STAFF ANALYSIS

Case No.:	Z-25-1247529	**Agenda #:** 2025-0628
Address:	3265 Northeast Expressway, Chamblee, GA 30341	**Commission District:** 01 **Super District:** 07
Parcel ID(s):	18-267-01-003	
Request:	Rezone property from C-2 (General Commercial) zoning district to HR-1 (High Density Residential-1) zoning district to allow single-family, attached, and multi-family developments.	
Property Owner(s):	Reality Income Corporation	
Applicant/Agent:	LMPSF acquisitions, LLC. c/o Troutman Pepper Locke, LLP	
Acreage:	36.46 acres	
Existing Land Use:	Formally Regal Cinemas	
Surrounding Properties:	**North:** OI (Office Institutional) **East:** OI **South:** MR-2 (Medium Density Residential -1), R-100 (Residential Medium Lot-100) **West:** C-2 (General Commercial).	
Comprehensive Plan:	RC (Regional Center) **Consistent** X **Inconsistent**

Staff Recommendation: Once Cycle Deferral.

SITE PLAN

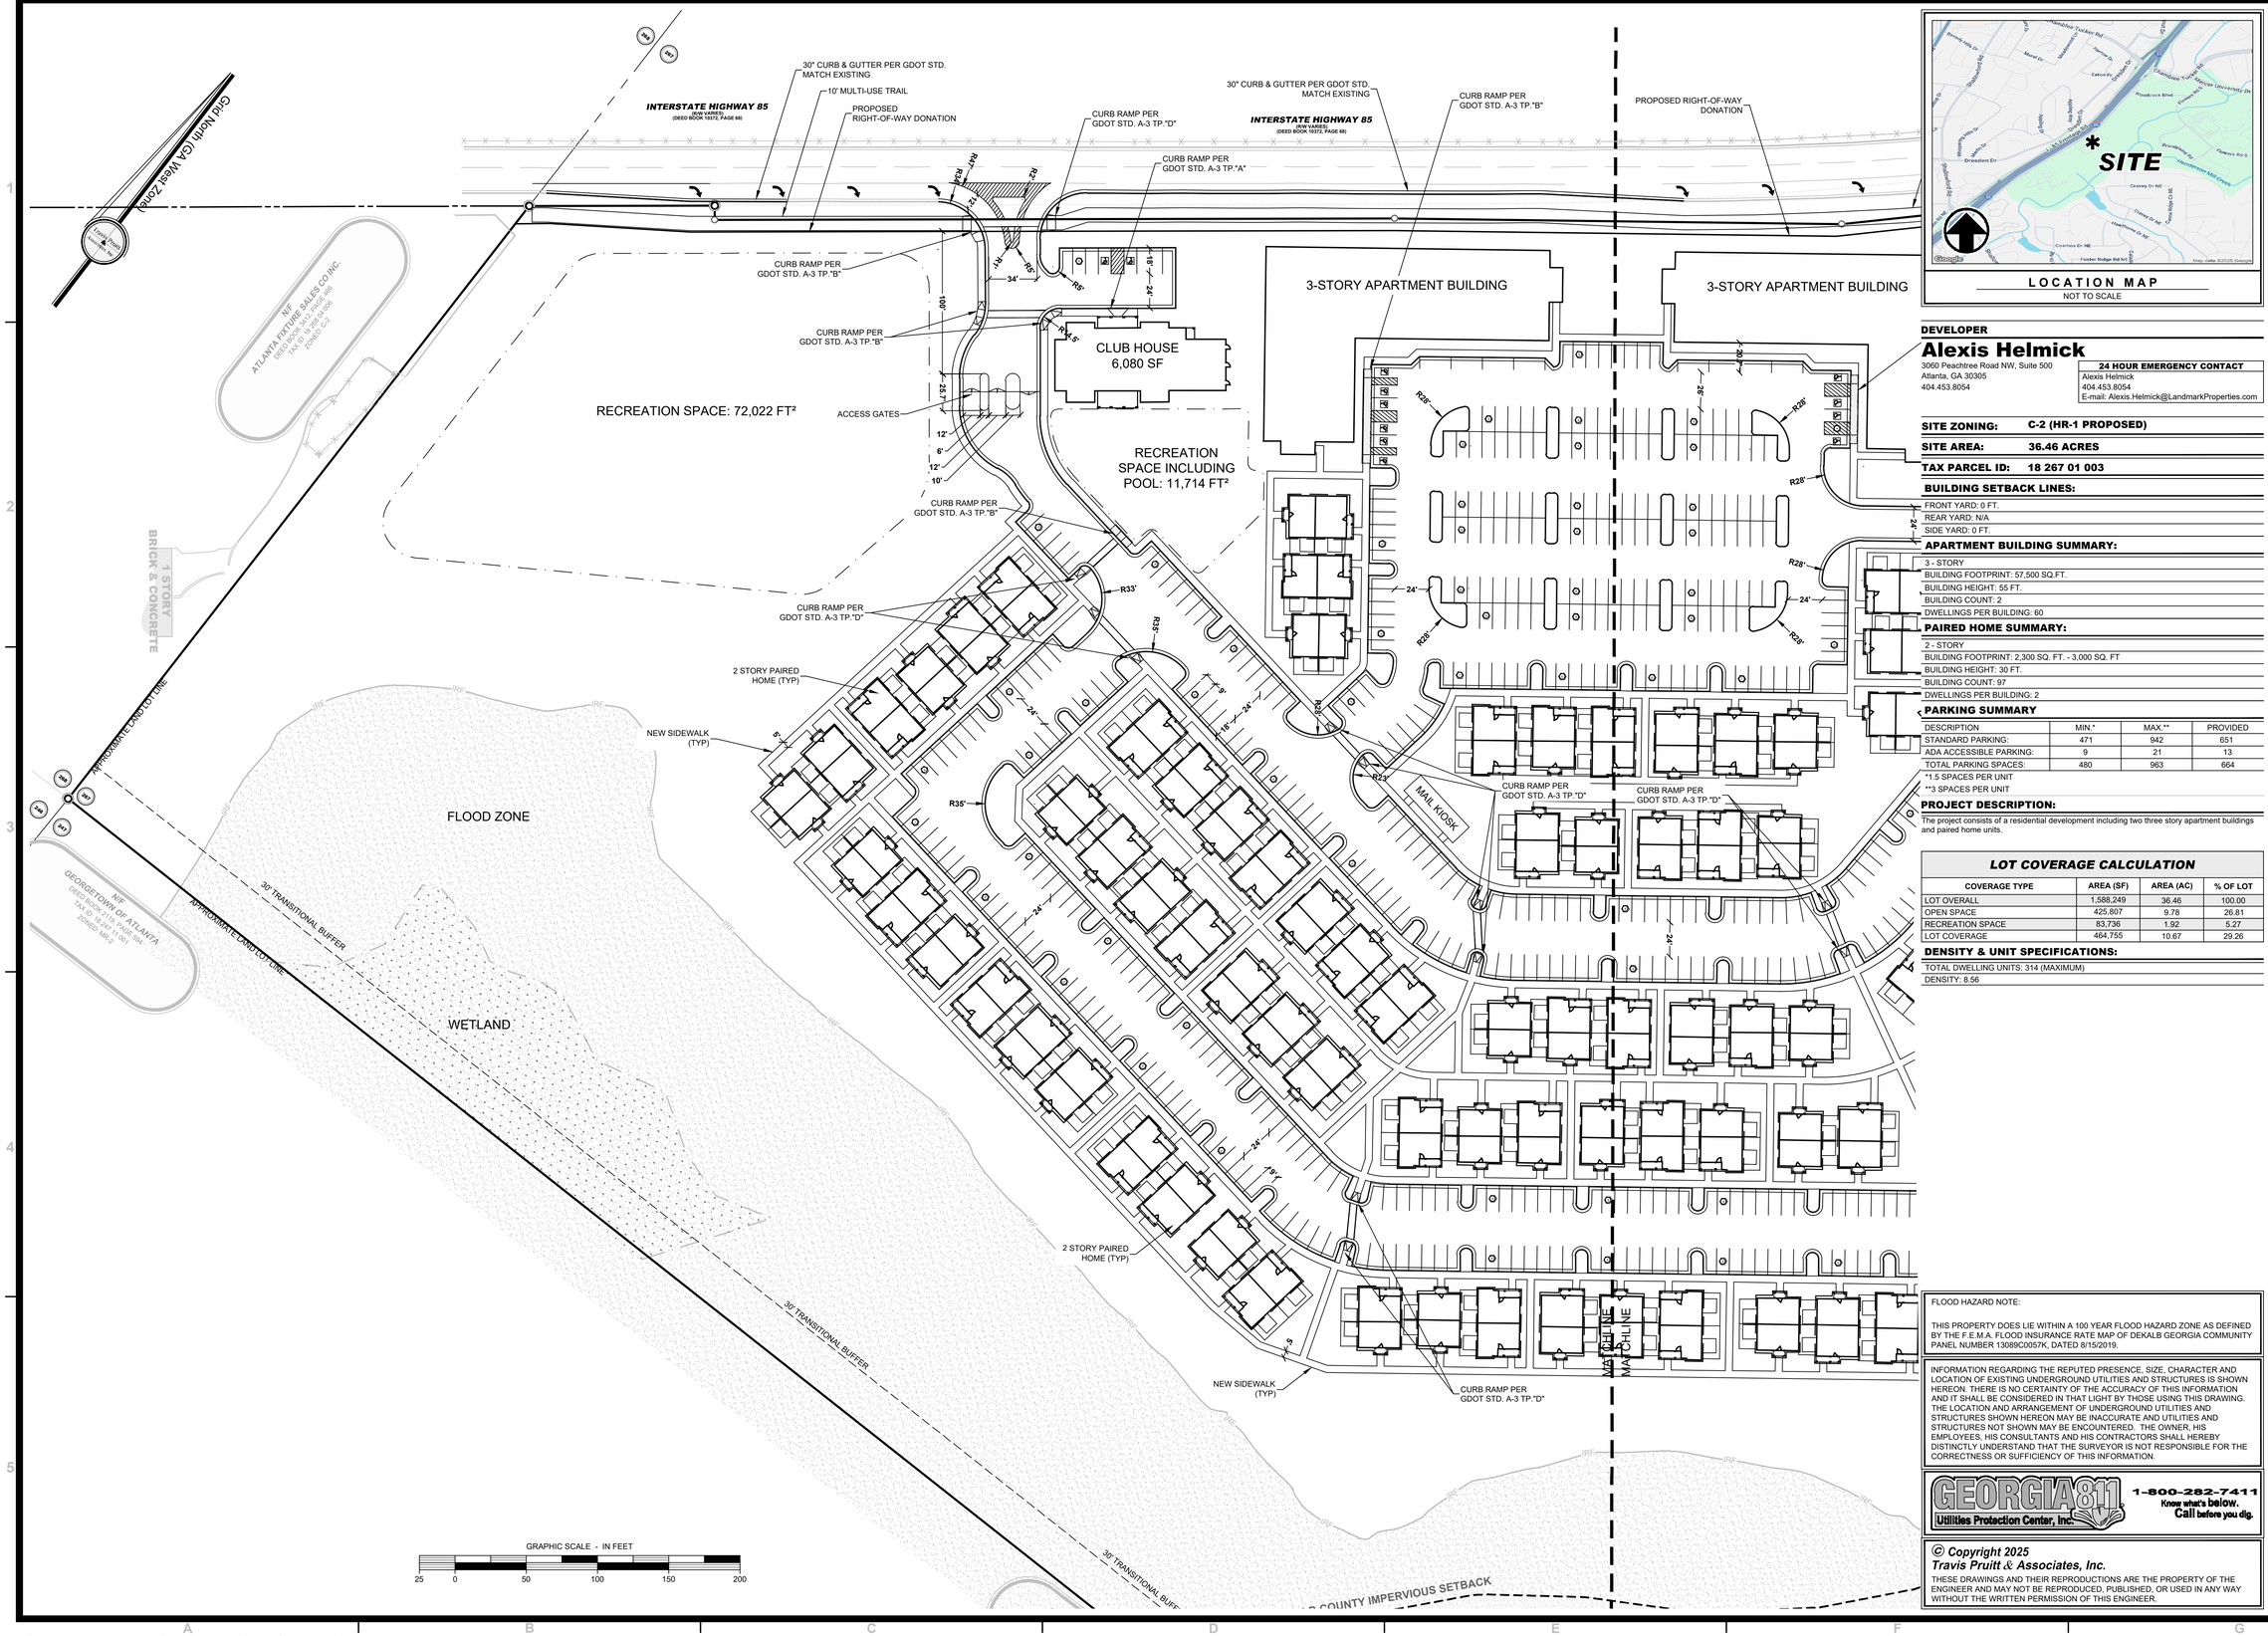
The applicant has proposed a density of approximately 8.5 units per acre, which is significantly lower than both the HR-1 maximum (40 units per acre) and the Regional Center (RC) Character Area, which has no maximum density. The RC future land use designation supports high-density, high-intensity development by encouraging mixed-use projects with 75 or more dwelling units per acre (*DeKalb 2050 Unified Plan, pg. 31*). These areas are defined by their accessibility to interstates, major roadways, transit, and trails, and typically feature campus-style or unified development patterns, higher floor-area ratios, and the integration of non-residential components. While the subject site aligns with several of the RC Character Area's desired physical characteristics—including its proximity to Mercer University, I-85, the ongoing construction of the Northfork Peachtree Creek Trail, and nearby redevelopment—the proposed development does not include any non-residential uses, which may limit its ability to fully support the mixed-use vision outlined for the RC Character Area.

Furthermore, the site lies within the *Presidential Parkway Regional Center*, *Area D – Edge 1*, which allows up to twenty-four (24) units per acre and a building height of four (4) stories. While the maximum density (24 + u/acre) may not be achievable, the proposed (8.5 u/acre) is well below recommendations for Area D. A higher density may be feasible and would still provide an appropriate transition to nearby residential areas while better supporting the goals of the *Presidential Parkway Regional Center*.

As this corridor continues to experience redevelopment and a SAP (Small Area Plan) is underway, careful consideration should be given to the cumulative impact of residential-only projects in an area designated as a RC. While the proposal contributes to a diverse housing supply, a more balanced mix of uses will be critical to avoid repeating low-intensity, suburban-style development patterns on large, well-positioned parcels. Thoughtful inclusion of non-residential uses**,** whether through vertical or horizontal mixed-use, can better serve the long-term function of the RC. For revisions to conditions pertaining to the overall development of the site, particularly the proposed density, Staff recommends a ***"Full Cycle Deferral to the November 2025 zoning agenda"***.
